SEDGWICK COUNTY JUVENILE DETENTION CENTER
AN ADDITION TO WICHITA, SEDGWICK COUNTY, KANSAS

RE: SUB 2003-80: One-Step Final Plat -- Sedgwick County Juvenile Detention Center Addition

RE: SUB 2003-80: One-Step Final Plat -- Sedgwick County Juvenile Detention Center Addition

CASE NUMBER: SUB 2003-80 -- SEDGWICK COUNTY JUVENILE DETENTION
CENTER ADDITION

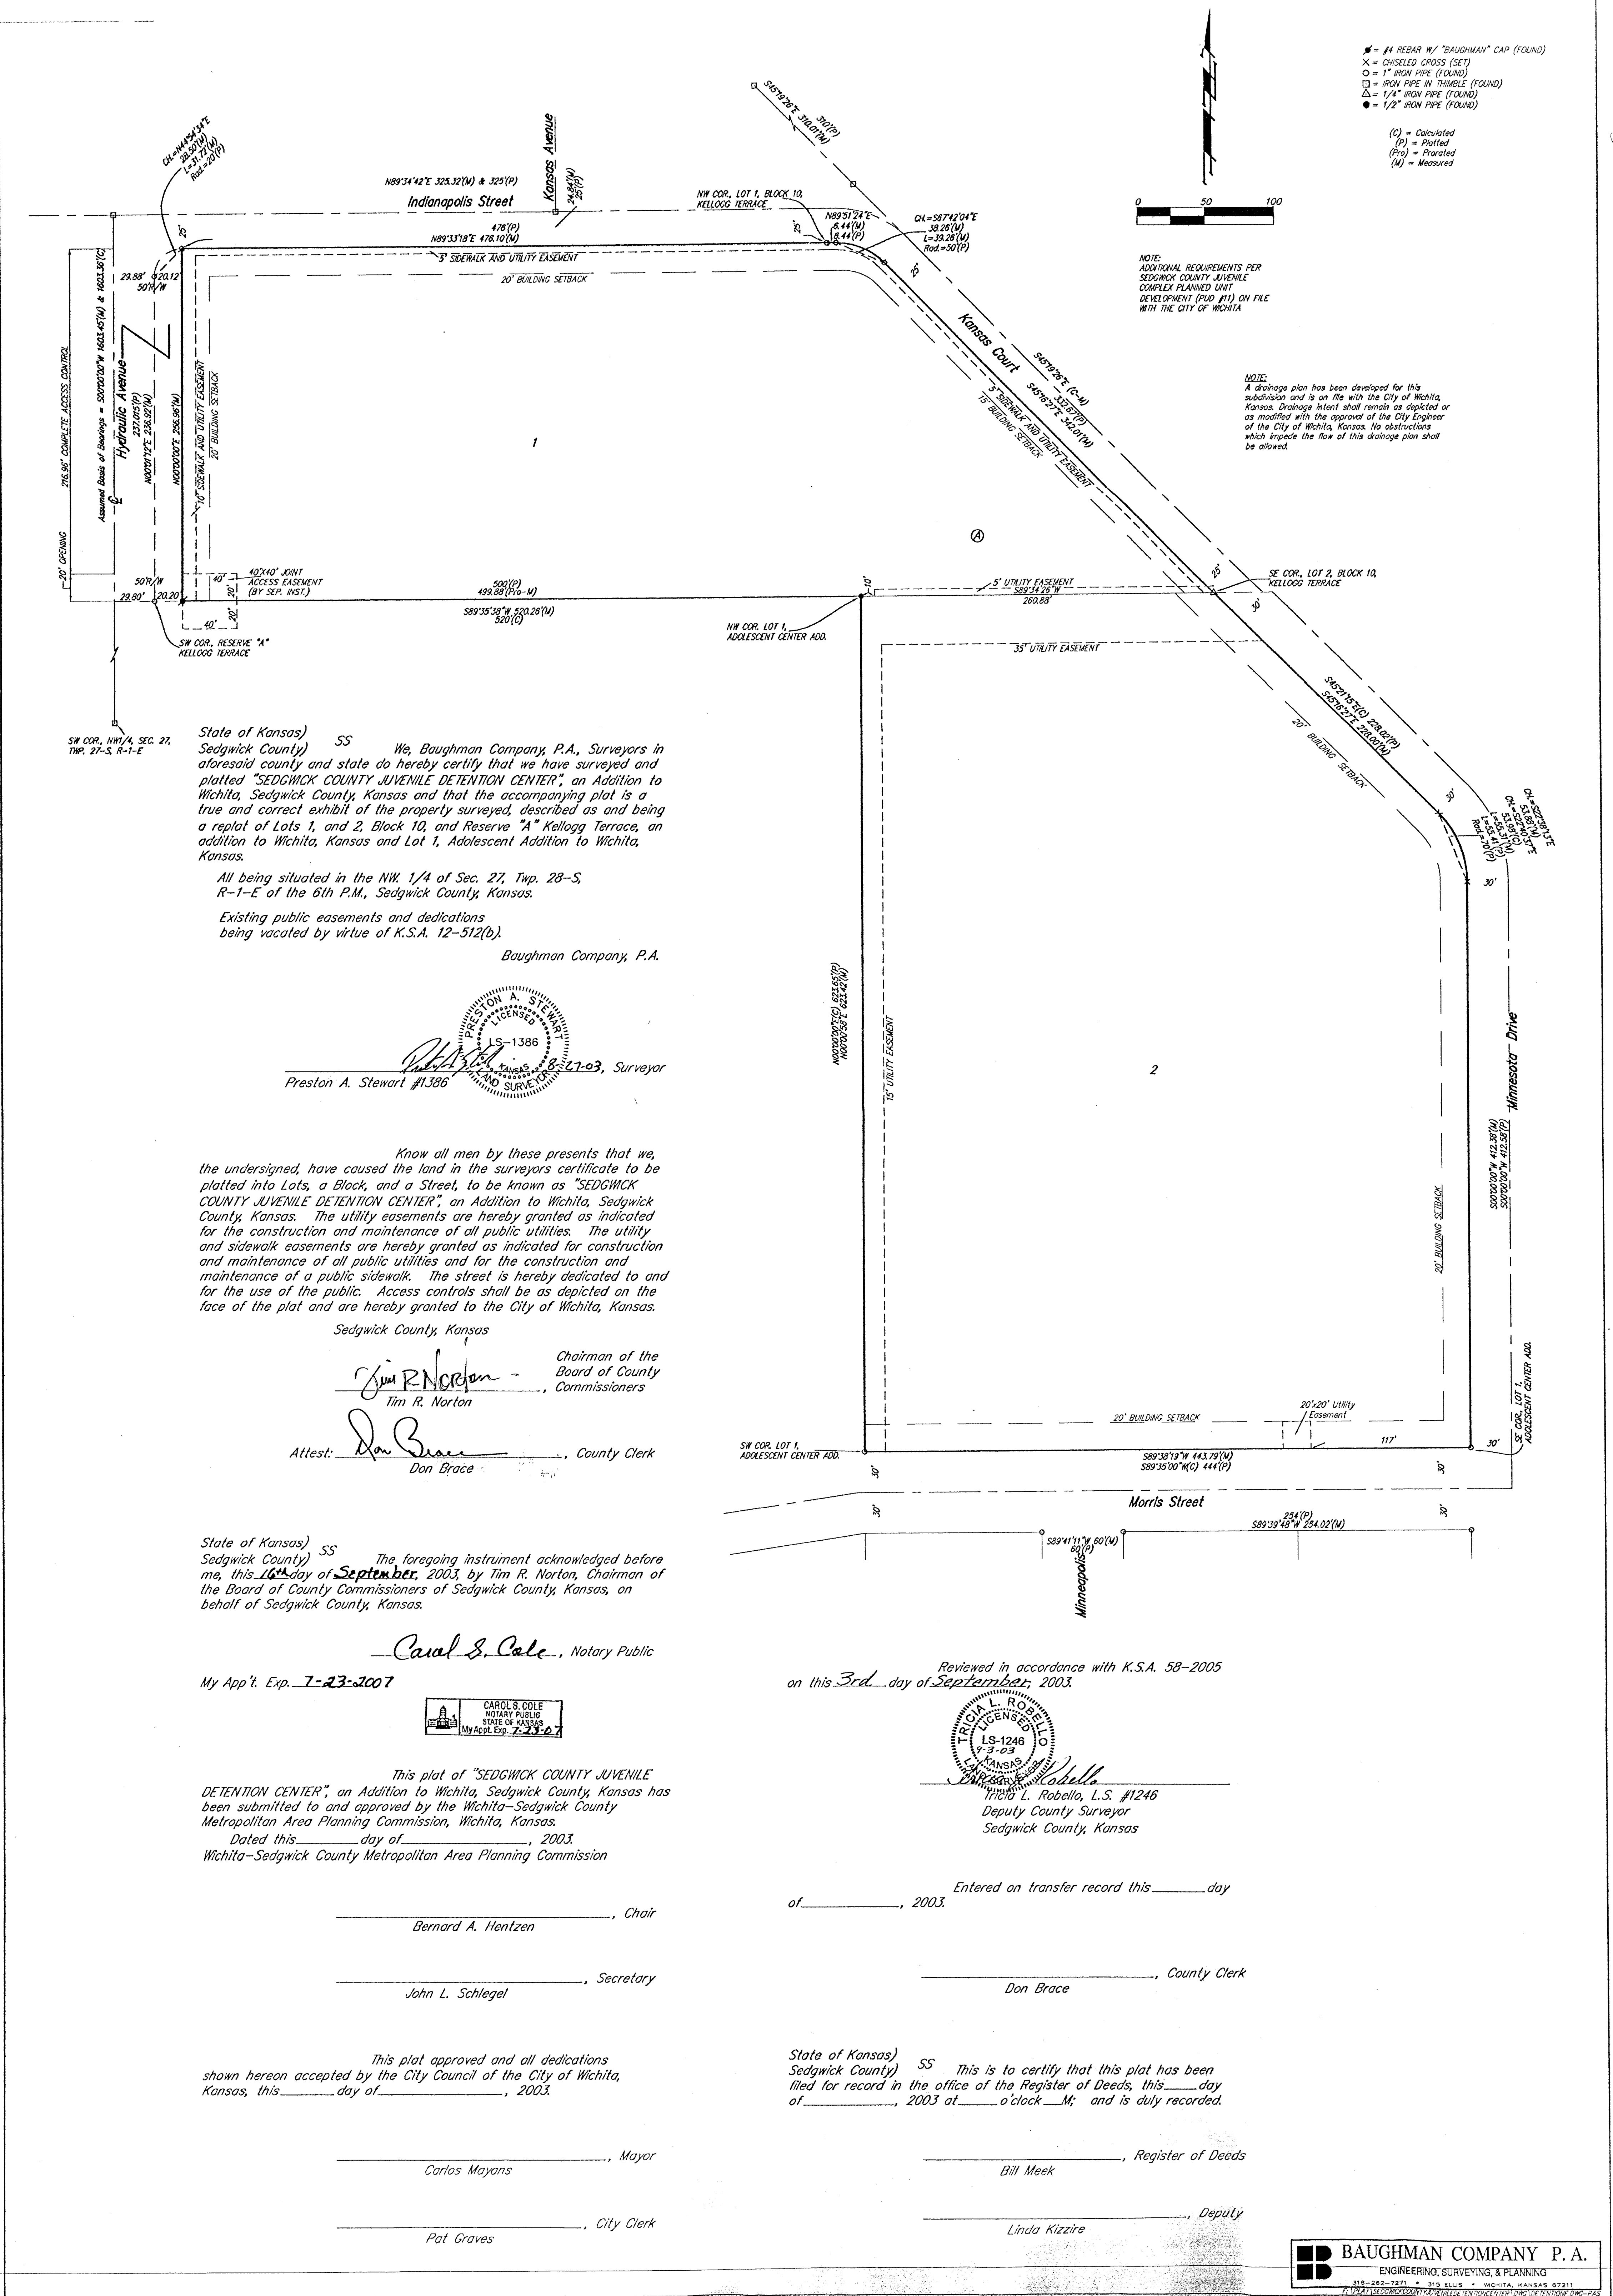
- C. City Engineering needs to comment on the status of the applicant's drainage plan. The drainage plan is approved.
- D. Traffic Engineering needs to comment on the access controls. The plat proposes one access opening along the south 40 feet of the Hydraulic frontage. Traffic Engineering has approved a shared access opening with the adjacent property to the south.

- F. Traffic Engineering has requested 10 feet of additional street right-of-way along Hydraulic. The Access Management Regulations require a 60-ft half-street right-of-way width along urban arterials. In lieu of a right-of-way dedication, a 10-ft sidewalk and utility easement has been approved.

- G. Traffic Engineering has requested 5 feet of additional right-of-way along Indianapolis and Kansas Ct. In lieu of a right-of-way dedication, a 5-ft sidewalk and utility easement has been approved.

- H. A note shall be placed on the final plat, indicating that this Addition is subject to the conditions of the Sedgwick County Juvenile Complex Planned Unit Development (PUD #11).

- I. The setback along Kansas Court does not conform with the building setback line which was established by the PUD. *The applicant will be requesting a PUD adjustment to reduce the setback.*

- J. *City Water and Sewer Department* needs to comment on the proposed wall located along the west property line of Lot 2 which is within a 15-ft utility easement. *City Water and Sewer Department requests that any new wall be constructed outside of the easement.*

- L. The plat's text shall include language that a drainage plan has been developed for the plat and that all drainage easements, rights-of-way, or reserves shall remain at established grades or as modified with the approval of the applicable City or County Engineer, and unobstructed to allow for the conveyance of stormwater.
